Amendments/Additional Information

From: Helen Webster
Sent: 20 April 2017 17:58
To: Planning
Subject: FW: NYM/2017/0168/FL Rear Dormers Rose Tree Cottage E10965-07 client drg 20_04_17
Attachments: D10965-03C.pdf

From: Neil Duffield
Sent: 20 April 2017 17:39
To: Helen Webster
Subject: NYM/2017/0168/FL Rear Dormers Rose Tree Cottage E10965-07 client drg 20_04_17

CLIENT:	Ms A Arnold
PROJECT:	Rose Tree Cottage Fylingthorpe
DRAWING STATUS:	Preliminary
DRAWN:	C. Eynon
CHECKED:	N I Duffield
SCALE & SIZE:	1:50 @ A1
DATE:	15/02/17
DRAWING NO.:	D10965-03
REV:	C

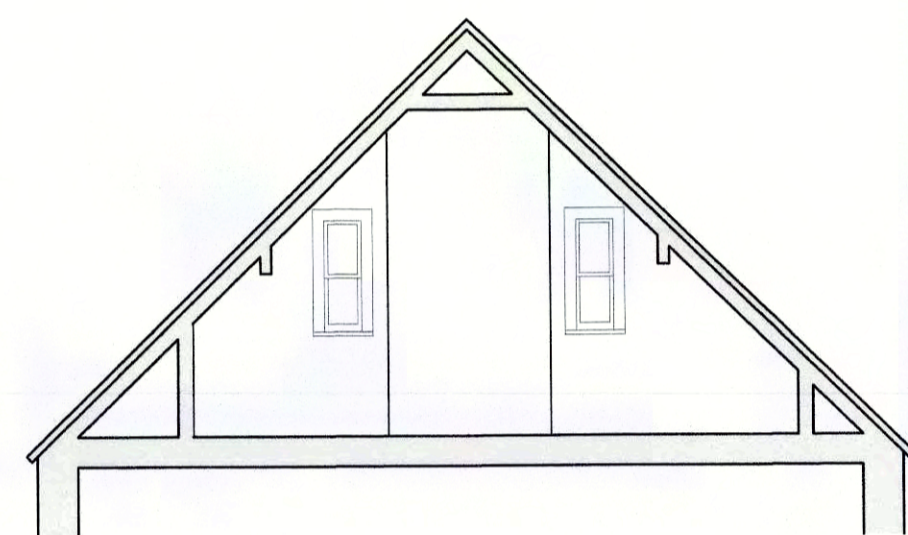
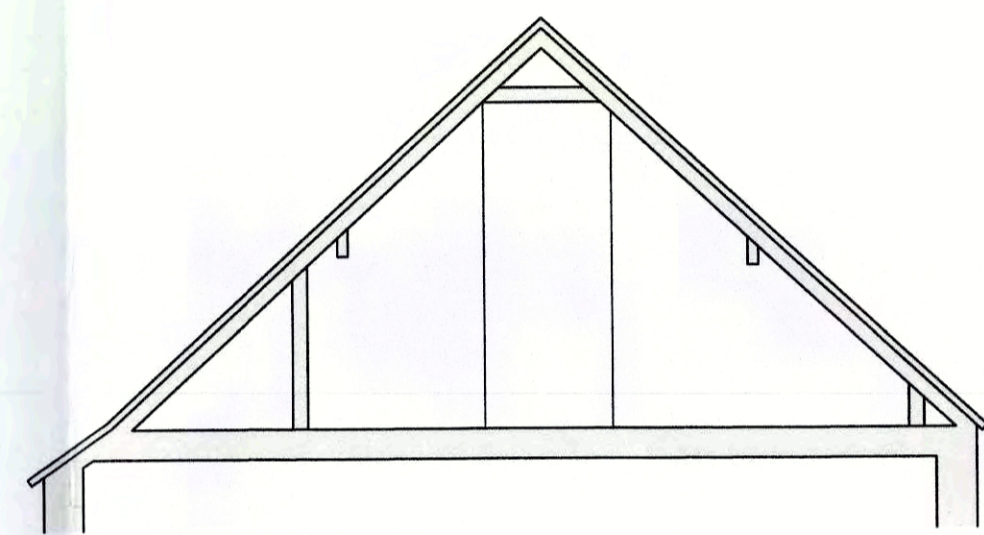
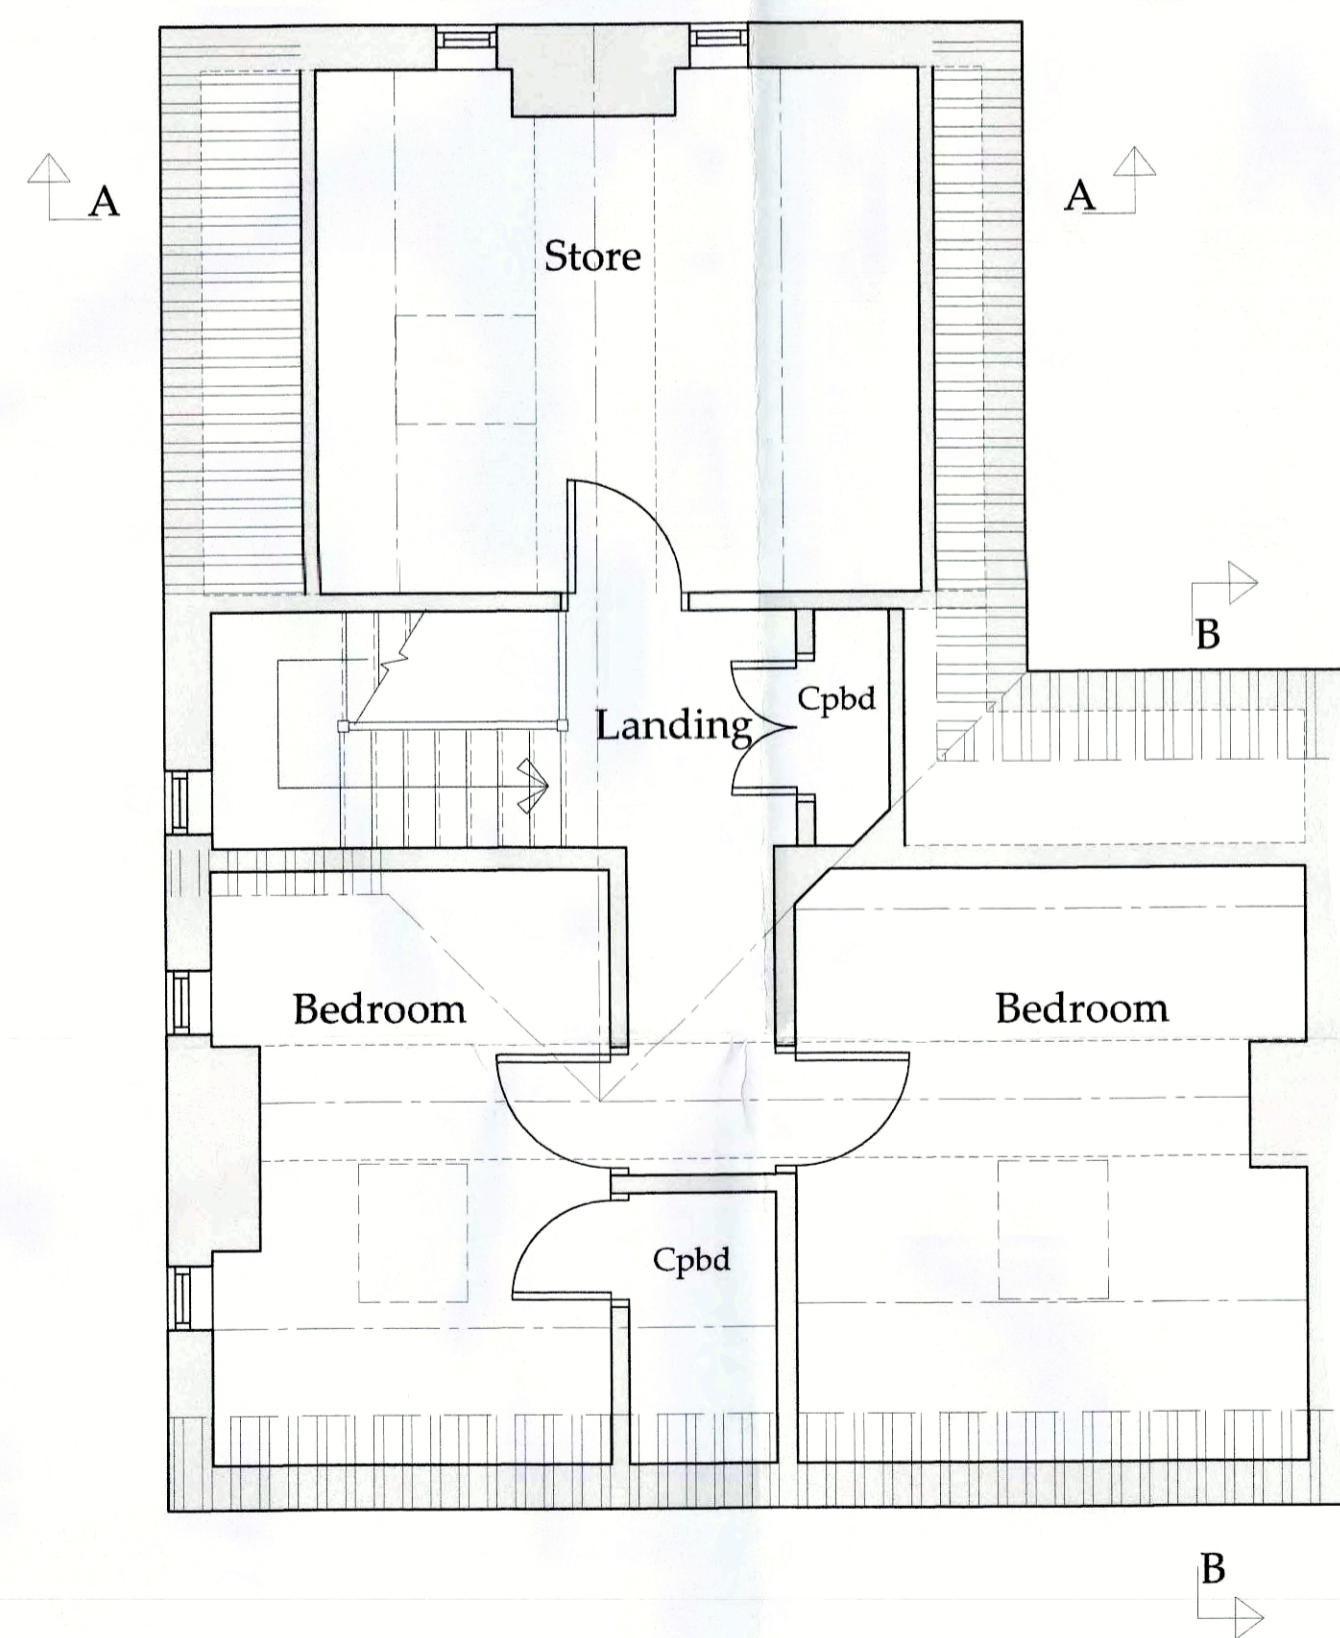
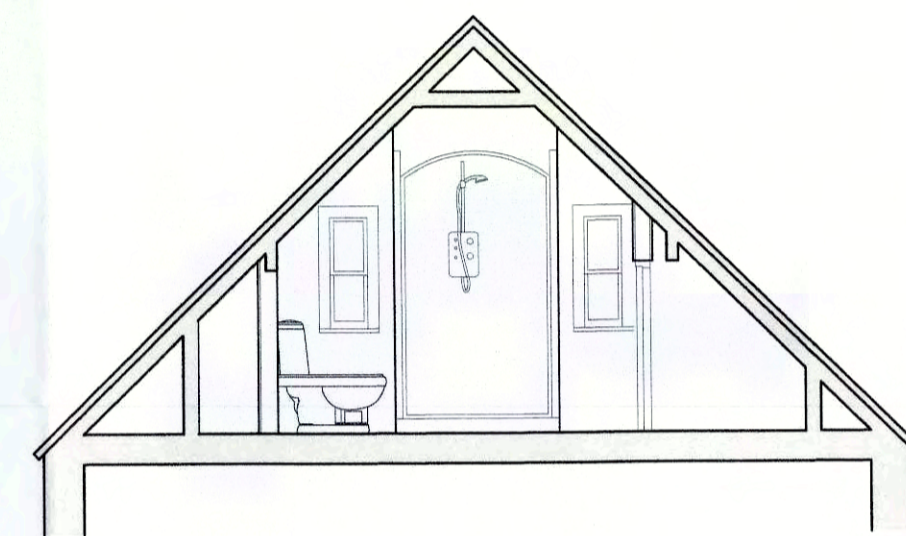
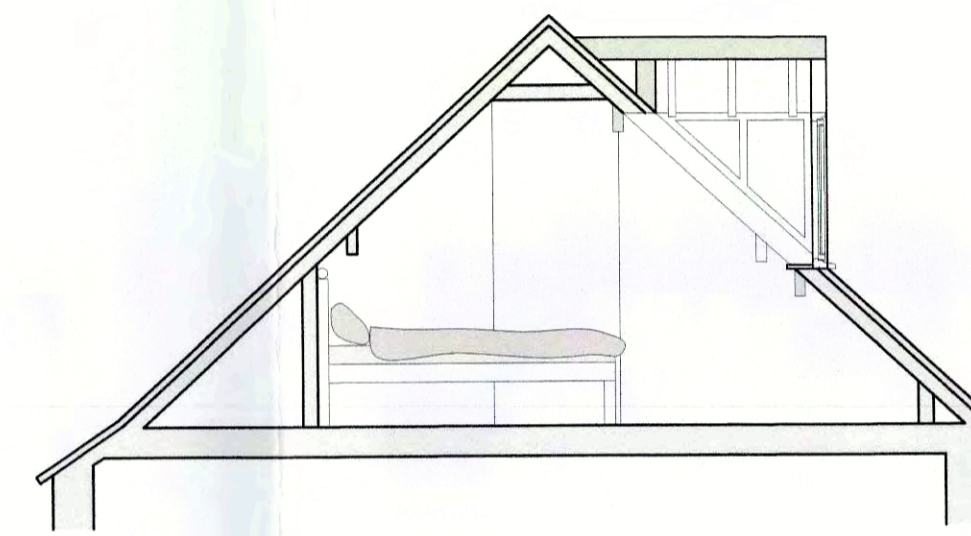
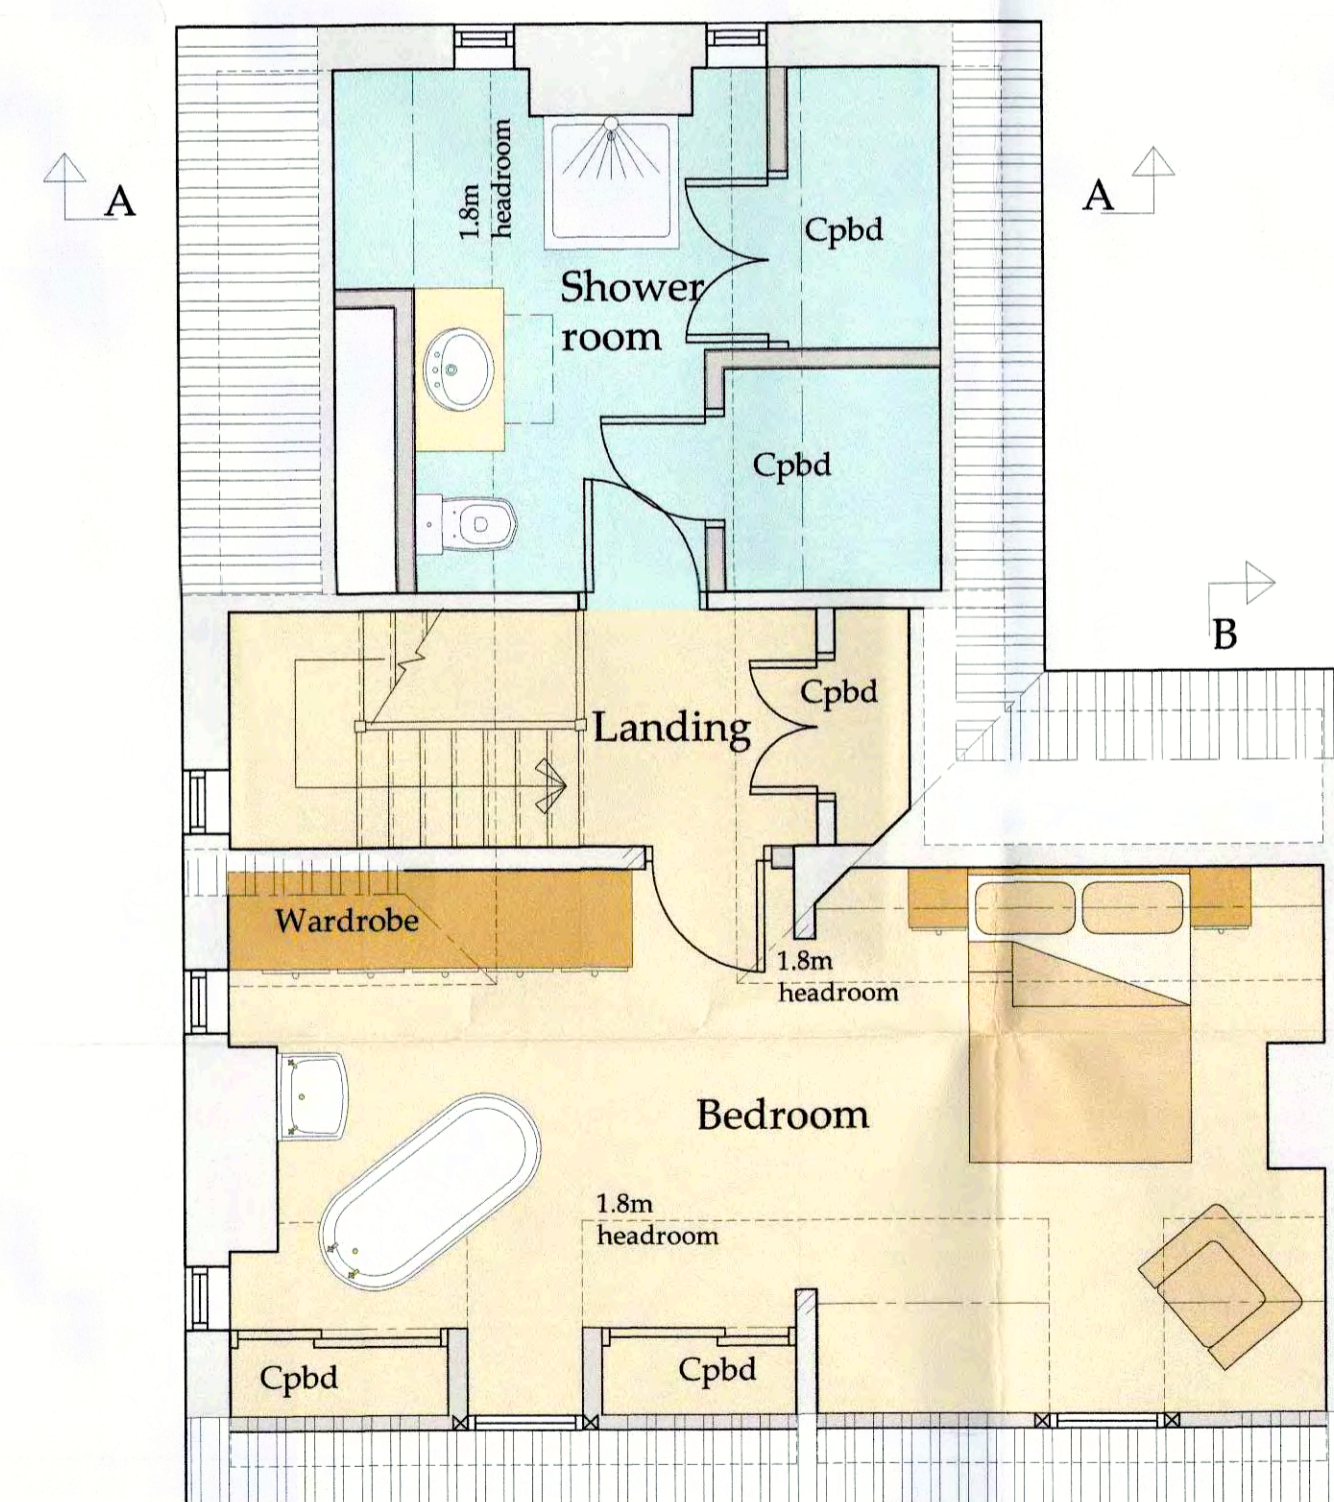
Following our conversation last week I attach a copy of the revised drawing D10965-03C with reduced dormer windows.

I appreciate your comment regarding 'Yorkshire' style dormers but having shown the gabled vertical sliders I believe the proportions look correct.

The windows are smaller than those below on the first floor in both dimensions to ensure this is the case.

2 No. Proposed Dormer windows 1.35m wide fully glazed with cill at 600mm high.

REV	DATE	BY	AMENDMENT
C	20/04/17	CE	Amended to suit planners
B	21/02/17	CE	Elevations added
A	15/02/17	CE	Issued for approval.
